Independent Daylight & Sunlight Review Proposed Redevelopment

219-233 Coldharbour Lane, London SE5 Revised scheme application 29 October 2020

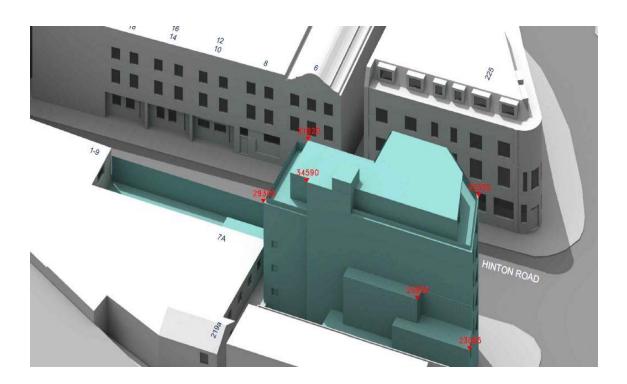
An amended scheme was submitted in February 2020, the results produced for this were only those relating to the rooms within 215-217 with an altered rear elevation as below.

This is as compared to the original elevation as below.

6.7 The revised analysis of the light to the Flats shows the daylight as follows as compared to the original results:

VSC Loss Original	VSC Loss New	VSC Retained New	ADF Retained Original	ADF Retained New	DD Retained Original	DD Retained New
Ground floor flat lounge	63.34%	29.28%	15.19%	0.63%	1.39%	70.7 sq ft	85.6 sq ft
First Floor Flat lounge	60.28%	32.27%	21.09%	1.03%	1.33%	152.8 sq ft	193.3 sq ft

- 6.8 It is clear the adjustments to the scheme have reduced the impact to the two flats in question and left them with more light.
- 6.9 In terms of the first floor flat, it is clear that the DD contour covers a significant amount of the room area and its ADF is approaching the requisite 1.5% for a lounge and given its retained VSC is over 20% we consider this will be sufficiently well lit.
- 6.10 In terms of the Ground floor it was clear from our internal inspection that the rear part of the room was never directly lit by daylight being a relatively deep Lounge/Kitchen/Diner.
- 6.11 It was therefore clearly important to ensure as much of the true living space towards the front of the room remains as well-lit as possible.

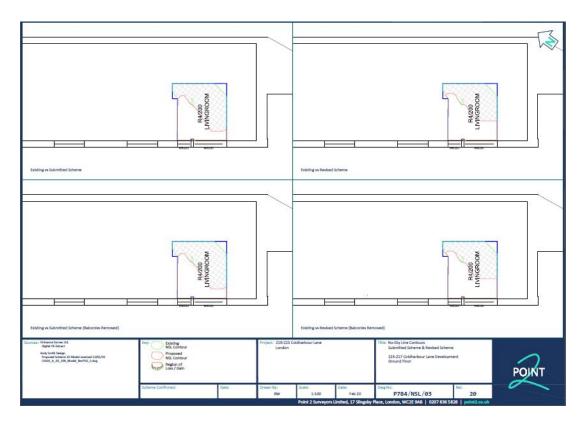
6.12 The two comparative contour plots below show the alteration between the original proposal and the new.

6.13 In combination with the ADF, the retained VSC level of 15.19% and the location of the area directly lit by Daylight we believe this flat will be lit to a level that is comparable to a normal residential unit in an urban area and therefore can be counted as being satisfactory in this case.
